October 31, 2024  
File No. 27224420.00

Mr. Mike Smith, P.E.  
Iowa Department of Natural Resources  
Land Quality Bureau  
6200 Park Avenue  
Des Moines, Iowa 50321

Subject: Request for Permit Amendment  
Revised Groundwater Underdrain System  
Loess Hills Regional Sanitary Landfill  
Permit No. 65-SDP-01-72  
Project No. 27224420.00

1 UNDERDRAIN PIPE TRENCH DETAIL  
NOT TO SCALE

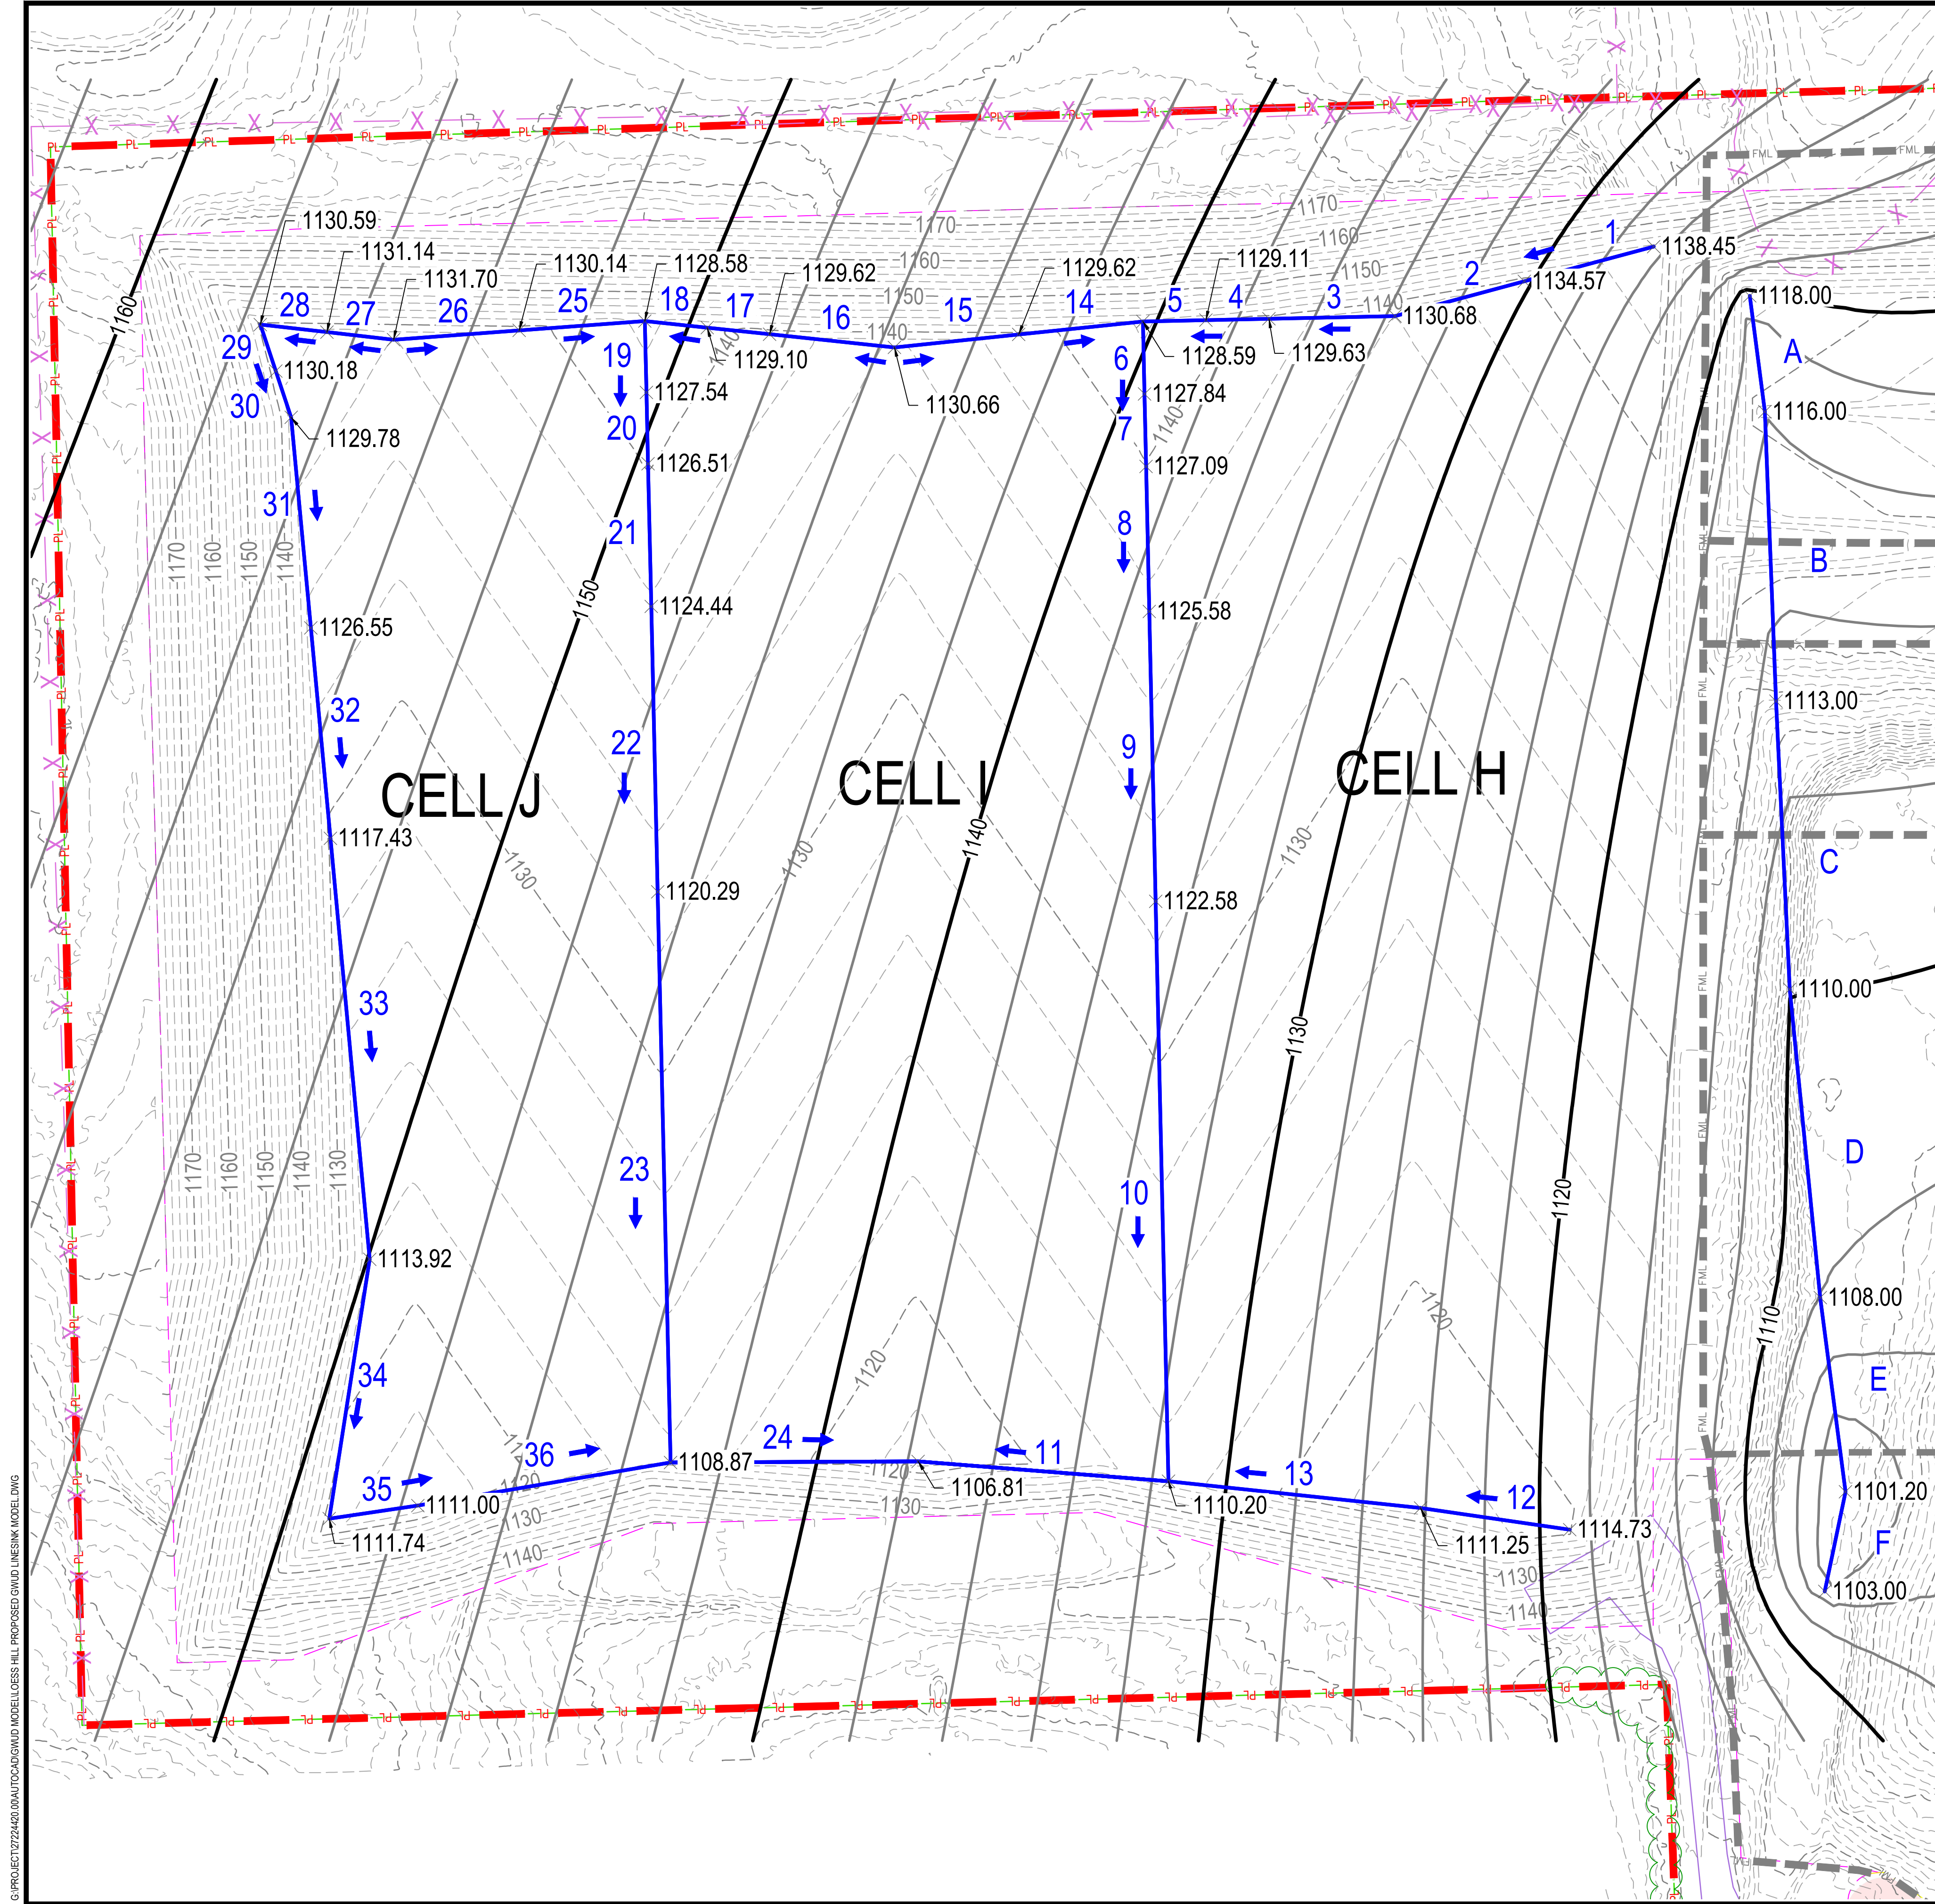
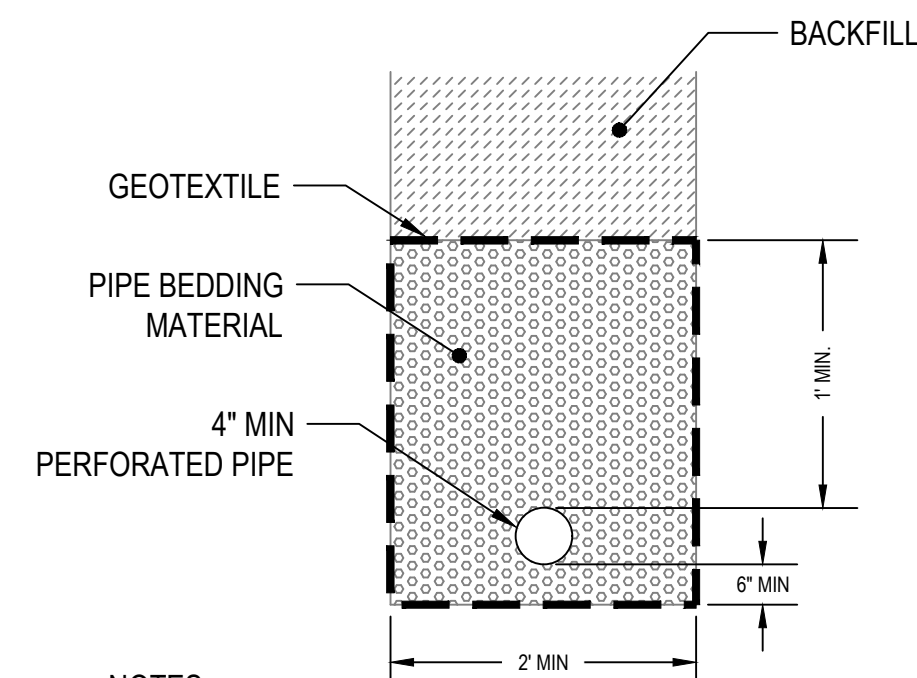
A typical cross-section detail of the proposed groundwater underdrain trench system is shown on Drawing A1 in Appendix A

The construction of the underdrain system will be in the same plan view location as the modeled line sinks. The depth of the trench below the liner is variable. The pipe invert elevations in the collection

trenches will be equal to, or lower than, the line sink elevations (a lower pipe invert is more conservative). There were two phases of line sink modeling:

A 4-inch perforated pipe is proposed for the underdrain collection system. The minimum slope of the collection system is 1.0% (except line sink 13 at 0.5%, which negligibly contributes to the system). The maximum modeled flow volume for the system 1,144.0 ft<sup>3</sup>/day. The maximum capacity of a 4-inch pipe at 1.0% slope is 16,487 ft<sup>3</sup>/day. This indicates that the underdrain system has over 14 times the necessary capacity managed the modeled flow volumes. Calculations are shown in Appendix B.

The previous pipe stability calculations (see Doc # 105401) assumed 235 feet of waste with 5.5 feet of cover soil above the pipe. The conditions of the cells analyzed herein show a maximum loading of approximately 140 feet of waste and 5.5 feet of cover soil. The additional loading of the pipes of the proposed underdrain system would be a maximum of 8 feet of additional soil to account for the

depth of trenches. The previous calculations determined that using 6-inch SDR 17 would be adequate. The proposed underdrain system will use 4-inch SDR 11 pipe which has significantly improved stability characteristics.

As the flow rate is variable depending on the line sink, the flow for each sink was divided by the length of the sink to generate a flow per linear foot. As shown in Tables C1, C2, and C3 in Appendix C, the groundwater inflow (Q) into line sink 29 was the worst-case scenario at 1.26 ft<sup>3</sup>/day/ft. The flow into the trench was assumed to happen only on the vertical side of the trench, so the area (A) is equal to 2 ft<sup>2</sup>. The hydraulic gradient (i) was conservatively assumed to be 0.01 ft/ft. A gradient of approximately 0.07 ft/ft was indicated by the modeled contours. The required permeability of the drainage media was calculated to be 2.22x10<sup>-2</sup> cm/sec. Therefore, an aggregate with a permeability of at least 5.0x10<sup>-2</sup> cm/sec is proposed for the trench aggregate. Calculations are shown in Appendix B.

- NOTES:**
- GEOTEXTILE AND PIPE BEDDING PERMEABILITY EQUAL TO OR GREATER THAN  $5.0 \times 10^{-2}$  CM / SEC
